**ADDENDUM NUMBER 3**

**Bid Number 00001736**

**CBWTP Headworks Screening Improvements**

Item No.	Location	Change
3.01	Bid Book Specifications Cover Page	<b>Modify</b> Bids Due date as follows:  BIDS DUE: <del>November 16</del> November 30, 2021
3.02	Site Inspection Visit	The City will offer the chance for Bidders to attend a 3rd Site Inspection Visit:  1. Monday, November 15th from 9:00 am to 11:00 am
3.03	TOC	<b>ADD</b> the following Sections to DIVISION 08 - OPENINGS:  08 11 13 Hollow Metal Doors and Frames 08 71 00 Door Hardware
3.04	03 30 00	Subparagraph 2.10.A.1.:  <b>DELETE</b> the following: 1. <del>“Minimum Compressive Strength: 5000 psi at 28 days.”</del>

JOB NO. E10805	1/4 SECTION
SHEET NO. S09	
X OF X

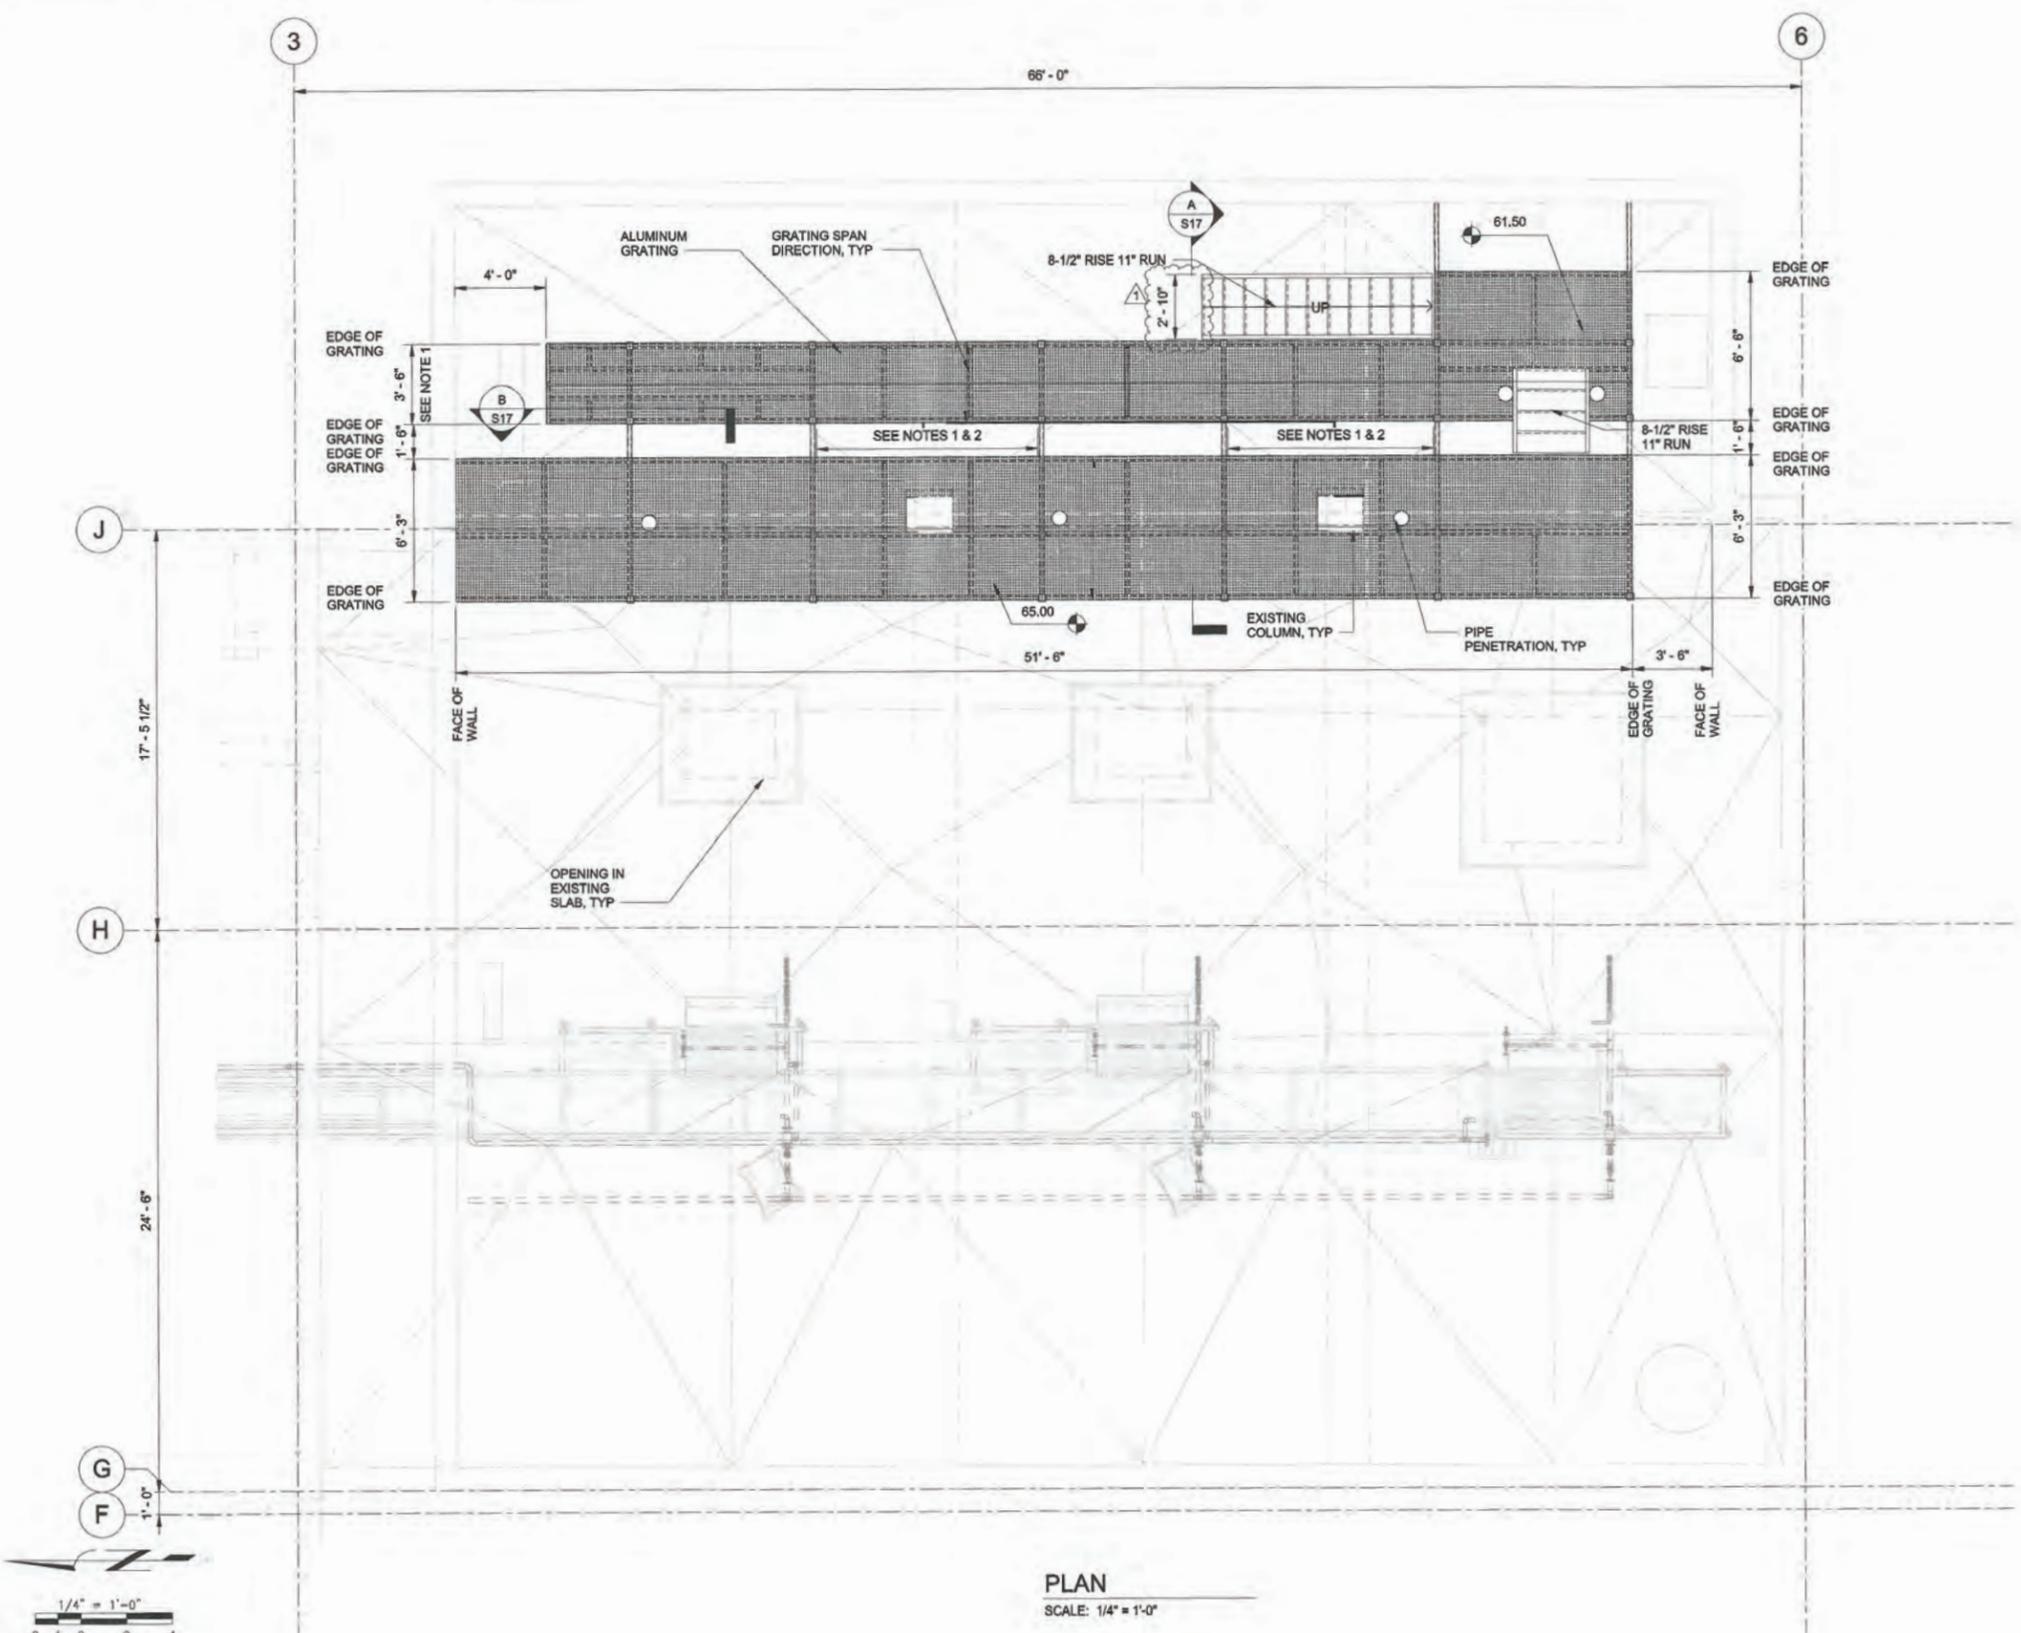
3.40	S09	<p><b>Question:</b> Per Note 3 / S09 for SS Lifting Ring of 2,000 lbs capacity, Note 3 shows Typ of 6 ea. However, we counted 12 ea on Dwg S09. Which Qty is true?</p> <p><b>Answer:</b> 12 is the correct answer.</p>

3.41	S09	<p><b>Question:</b> Per Note 4 / S09 for SS Lifting Ring of 1,000 lbs capacity, Note 4 shows Typ of 6 ea. However, we counted 17 ea on Dwg S09. Which Qty is true?</p> <p><b>Answer:</b> 17 is the correct answer.</p>

SOLIDS LOADING TIPPING TROUGH FRAMING PLAN FF EL 36.65

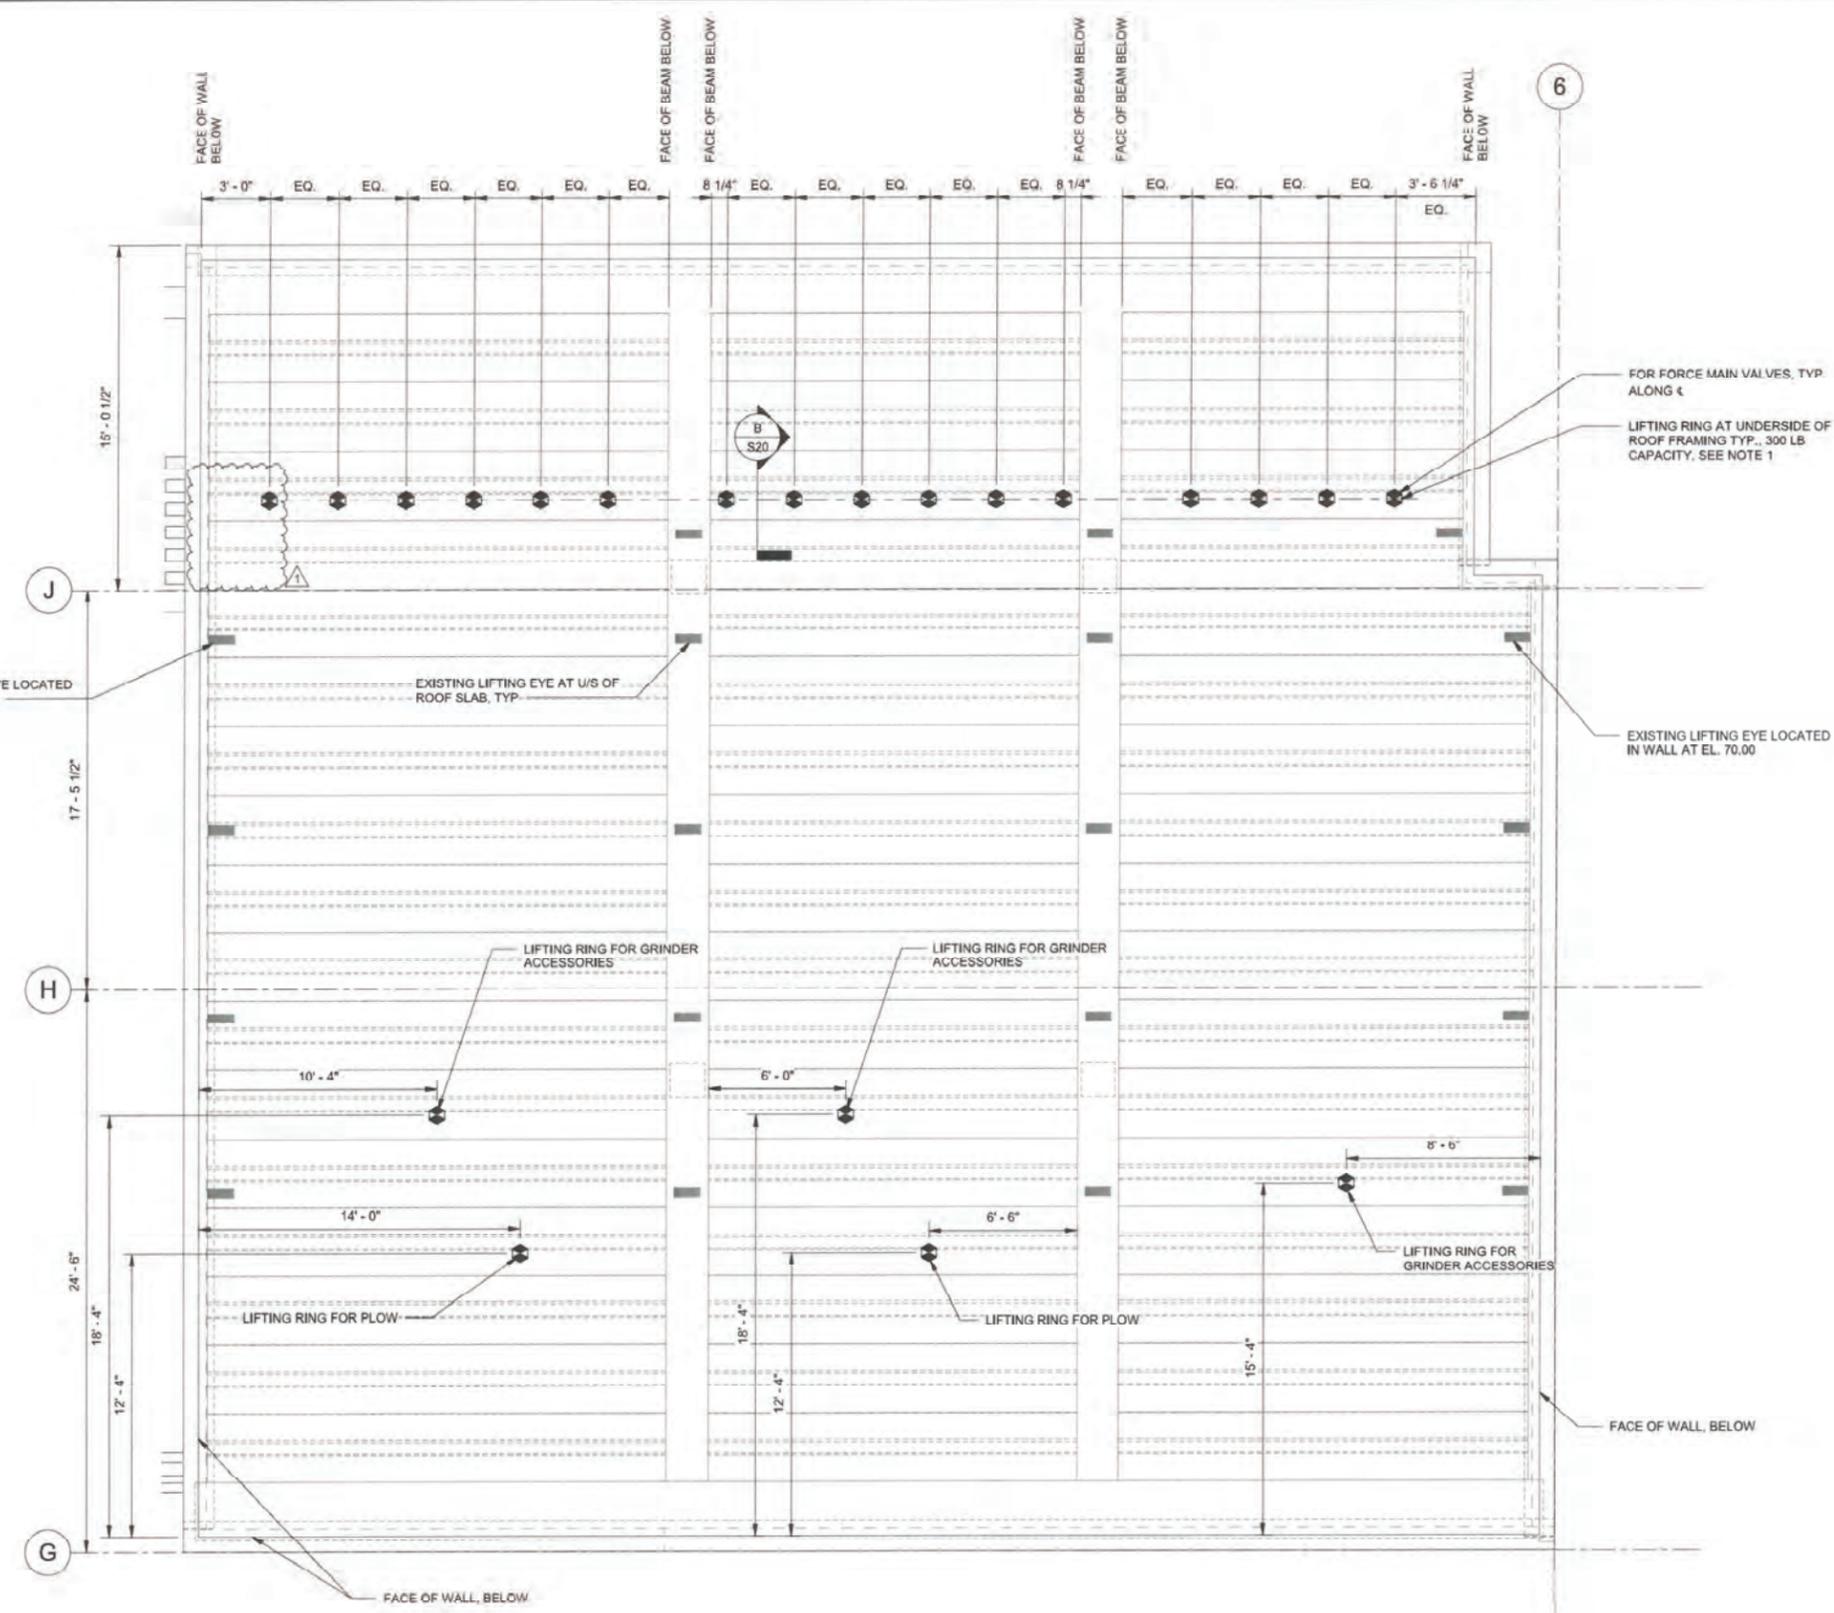
3.38	S05	<p><b>Question:</b> This sheet shows an area 25sqft demoed but S11 doesn't show it pouring back? Please advise</p> <p><b>Answer:</b> The contractor shall pour the concrete back. S05 shows the demolition of concrete. See revised sheet S12, issued in this addendum for new concrete placement.</p>

3.42	S12	<p><b>Question:</b> At Solids Loading Tipping Trough Framing plan, AL Stair Landing Grating has a call out 1 / S22. However, 1 / S22 is not a Grating detail. Should the actual call out be 1 / S23?</p> <p><b>Answer:</b> The correct detail reference should be Detail 1/S23. Callout is corrected on new revised sheet S12, see Addendum 3 item 3.19.</p>

**CBWWTP HEADWORKS  
SCREENING IMPROVEMENTS**  
UPPER LEVEL ELECTRICAL ROOM  
ULER SECTIONS AND ELEVATIONS

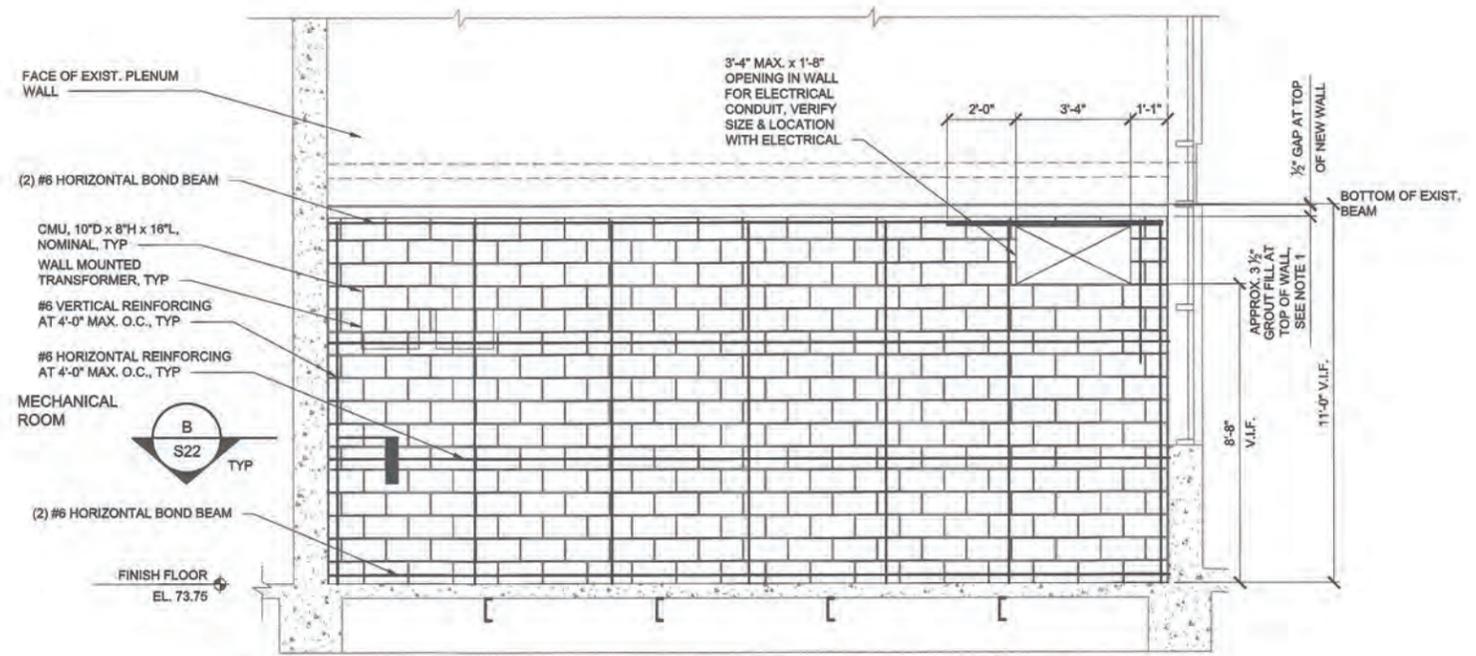
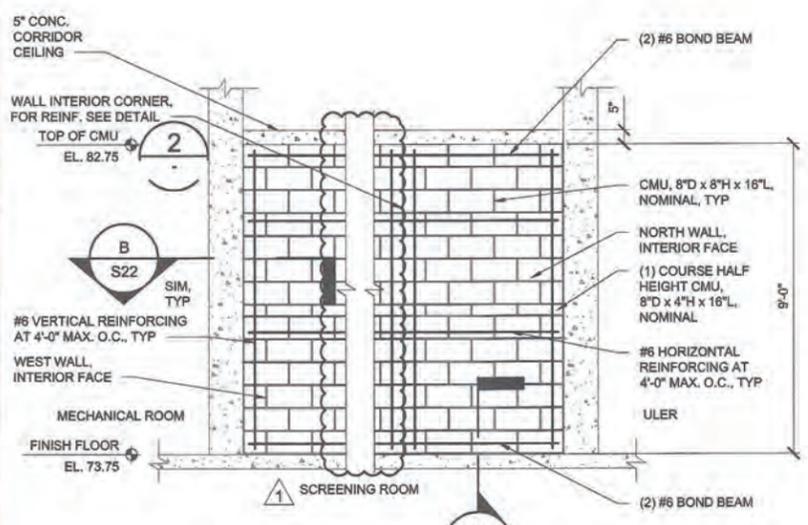
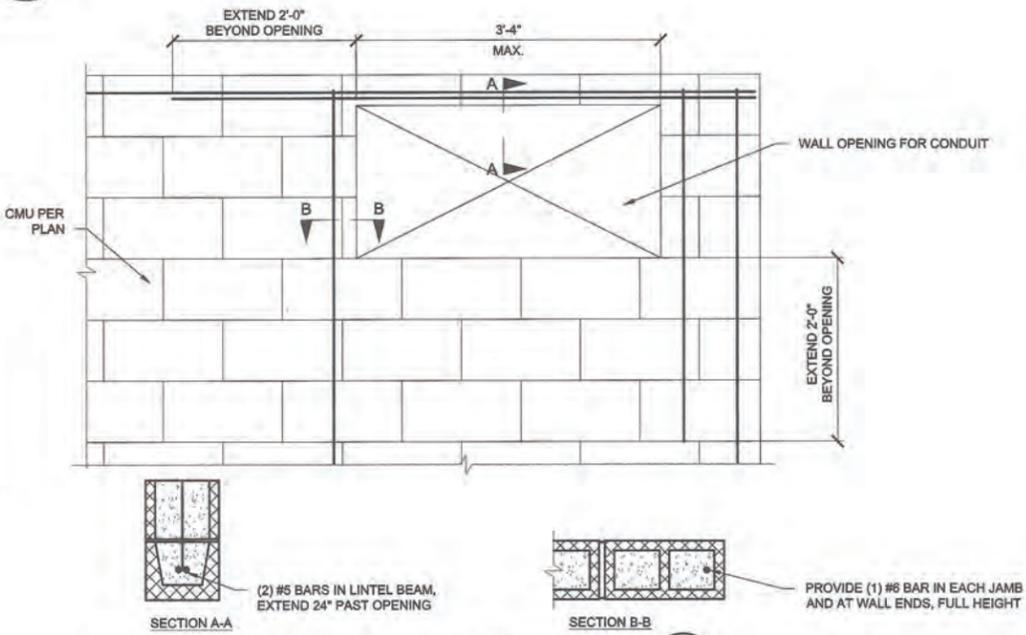
NO.	DATE	DESCRIPTION	APPD.	REVISION
1	10/15/21	ADDENDUM 3 - CORRIDOR WALL HEIGHT	PEK

CBWTP HEADWORKS  
SCREENING IMPROVEMENTS  
TYPICAL DETAILS I

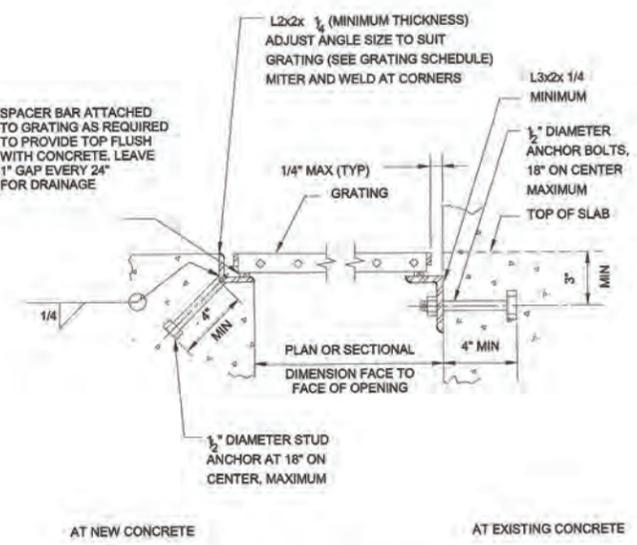
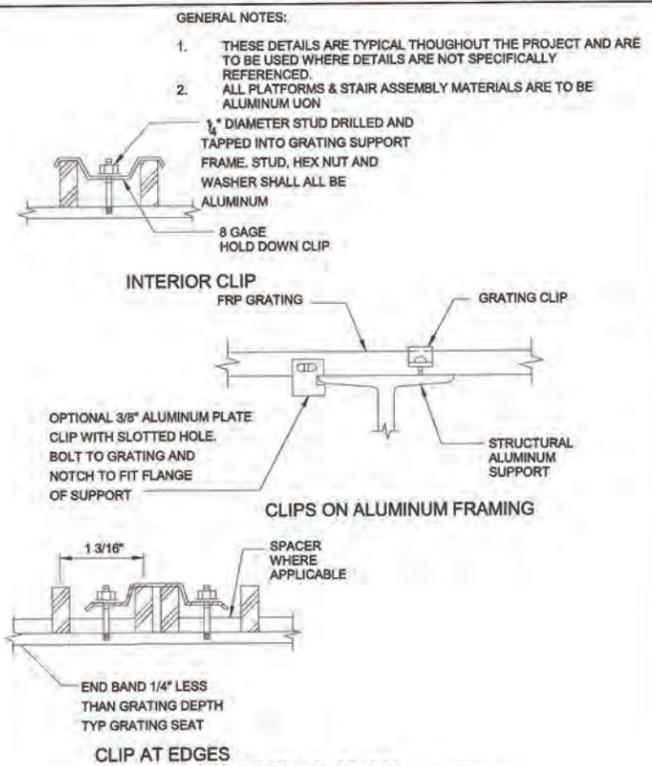
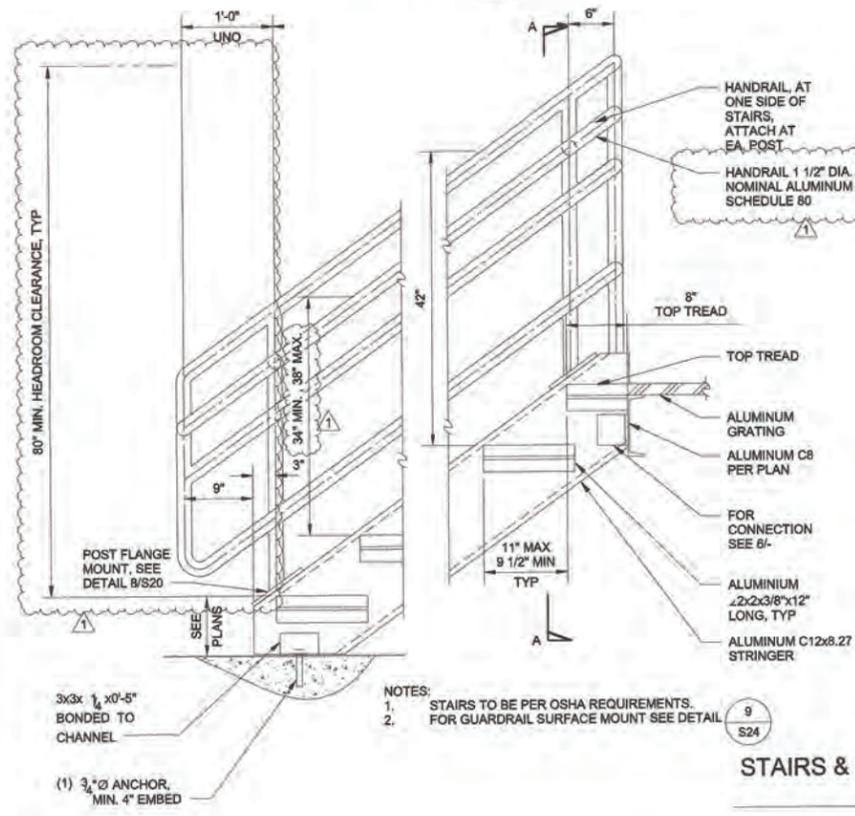
3.29	05 53 13	<p><b>Question:</b> The project specifications 05 53 13 Subparagraph 2.3 B., dimensions on bar grating are in conflict with the dimension in the typical details as shown on Sheet S23 detail 1. Please clarify the proper spacing. The attached detail is standard for fabrication and installation of clips.</p> <p><b>Answer:</b> The bearing bar spacing of 1 3/16" o.c. as shown on Detail 1/S23 is correct. See revised Specification language issued as Addendum 3 Item 3.06 above.</p>

3.45	S23	<p><b>Question:</b> Detail 4 / S23 shows a Stud / Machine Bolt config for Grating attachment. In our past projects, this config has been difficult to shop weld to ensure the studs will be centered between the Grating Bars. They often need to be cut off in the field for re-welding or shipped loose for field welding. Is it acceptable to use Self-drilling screws? If not, other manufacturers offer alternative types of grating clips that eliminate the need for field welding. If either of these alternative config is acceptable, it will save the cost for field welding of studs in between bearing bars.</p> <p><b>Answer:</b> Detail 4 / S23 has the grating clips held down by a stud with a hex nut, the stud is tapped into the grating support and no welding is required. Structfast's catalogue doesn't appear to include an aluminum grating to aluminum beam clip option, however, alternative grating clip designs will be considered. Contractor to submit requested grating attachments for approval during submittal approval process when under construction.</p>
